**HaskoningDHV UK Ltd.
Transport & Planning**

To: North Yorkshire County Council Highways
From: Sirius Minerals
Date: 24 March 2017
Our reference: T&PPB1110-112-107N001F0.1
Classification: Project related

Subject: Woodsmith Mine access proposals

TITLE ACCESS LOCATIONS	PROJECT SIRIUS MINERALS NORTH YORKSHIRE POLYHALITE PROJECT		JOB No. PB1110-112-107	DATE 23.03.17	SCALE N.T.S.
			DRAWN SKT	CHECKED RNE	PASSED RNE
			AUTOCAD REF.	DRG No. Figure 1

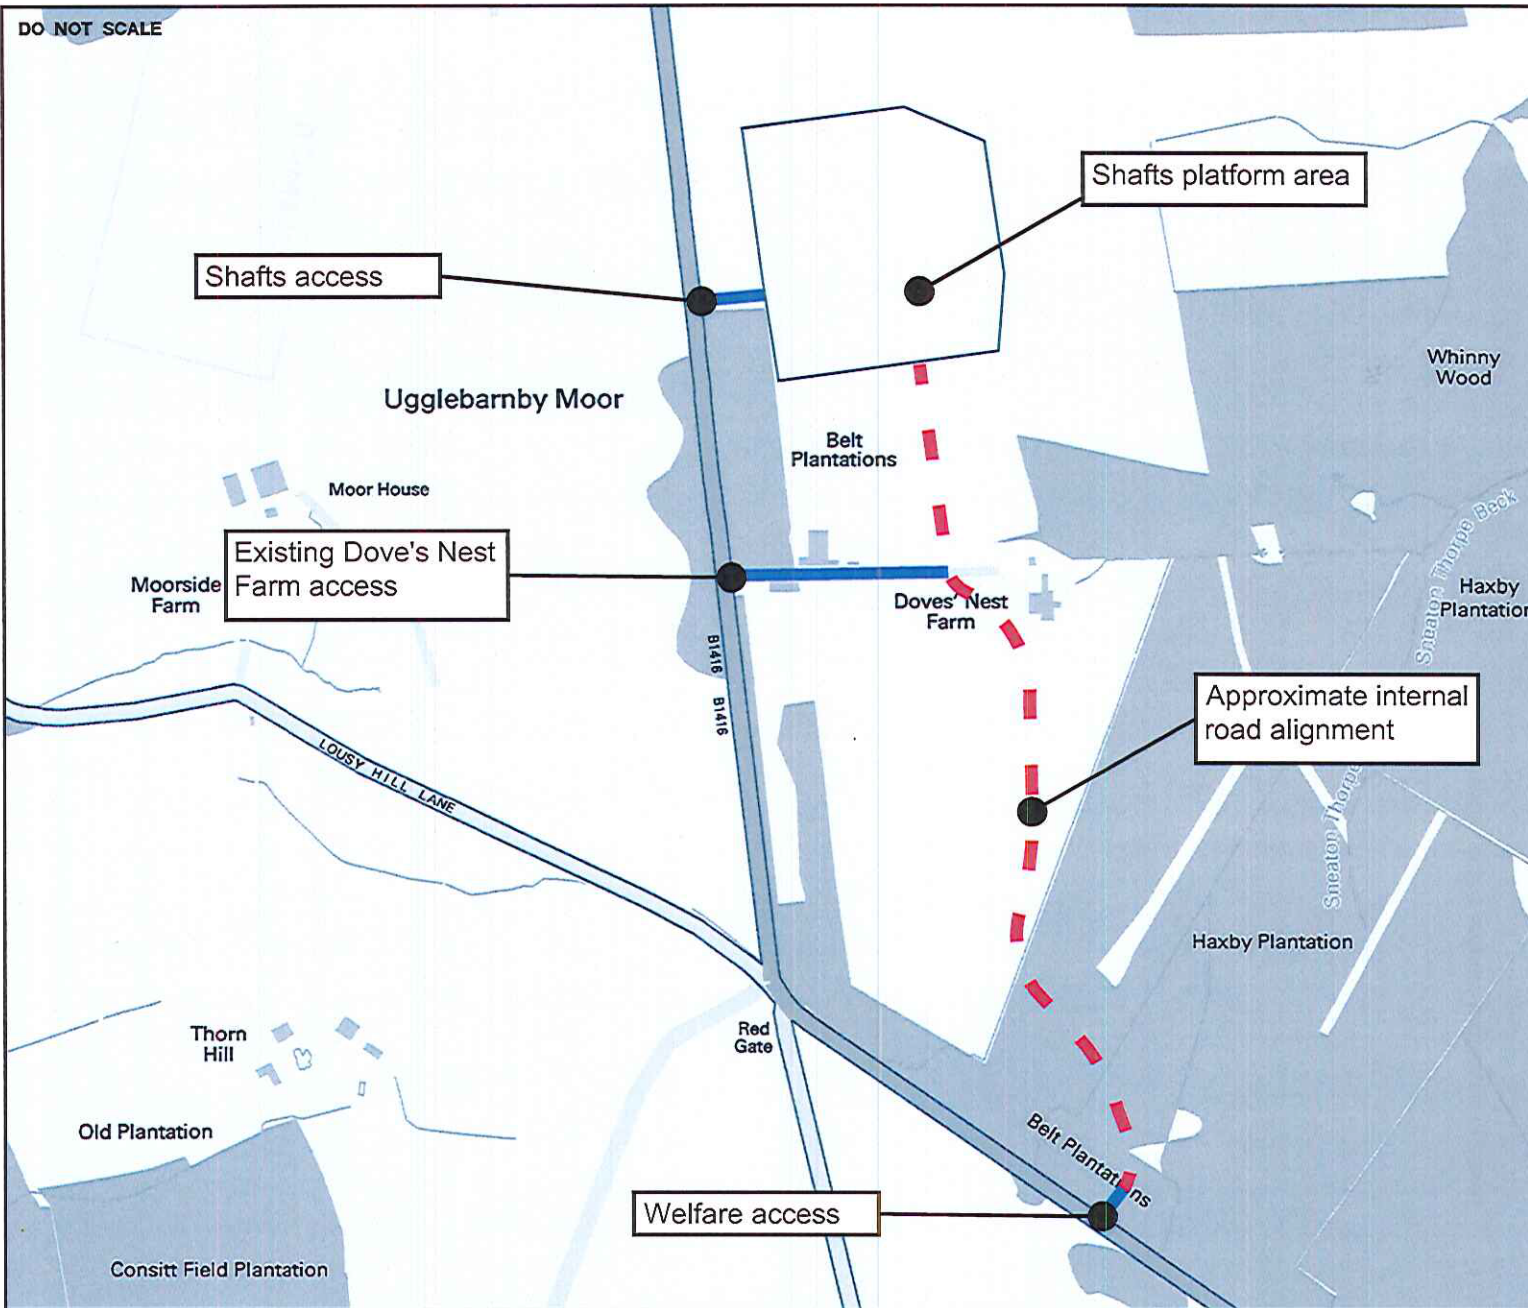
1.2.2 During the development of the application, it was proposed that the Shafts access would be used by construction traffic accessing the site from the B1416 until such a point as the internal access road linking to the Welfare access was completed. **Figure 1** provides a graphical depiction of the access locations.

1.3.1 In recognition of potential safety concerns regarding reversing onto the highway at the Welfare access and to maintain schedule it is proposed to use the Shafts access for a short period (approximately eight weeks). During this period, temporary traffic management measures will be employed rather than implementing a full right turn lane. After the eight week period all the construction traffic will revert to the Welfare access.

2.3.2 In capacity terms, the existing Shafts access priority junction can accommodate the peak of 33 deliveries per day (approximately three HGVs an hour). However, consideration also needs to be given to managing road safety.

2.3.3 Existing road safety measures currently in place (provided for the offsite highway works) include a 40mph speed limit and warning, and direction signs. Sirius Minerals has also confirmed that if required by NYCC Highways, they are committed to enhancing the existing road safety measures through the introduction of temporary traffic signal control.
